**In the Drawings**

### **REMARKS**

### **Drawings**

FIG. 3

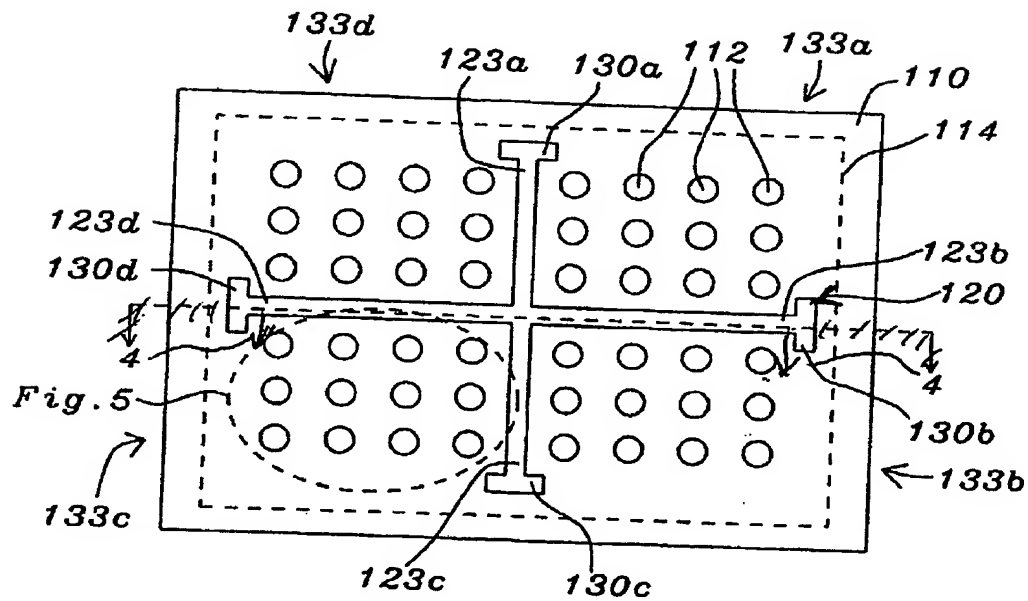
The drawings were objected to as not showing every feature of the claims (e.g. the metal trace structure being X-shaped, as claimed in claim 5, and the metal structure including a channel as claimed in claim 1).

The drawings were also objected to as being improperly cross-hatched.

FIGs. 3, 5, 6, and 8 are amended as illustrated in the accompanying annotated drawing sheets. FIGs. 9 and 10 are newly added as the attachment.

As noted above, Figs. 3, 5, 6, and 8 have been amended herein, as noted in the accompanying annotated drawing sheets. Also, new Figs. 9 and 10 have been added to illustrate the X-shaped structure that was specifically described in the specification (and claimed). As the subject matter of these drawings was described in the originally-filed specification, the addition of Figs 9 and 10 adds no new matter to the application. Also, the replacement drawing sheets have provided better spacing of the figures (by providing two figures per sheet, rather than three).
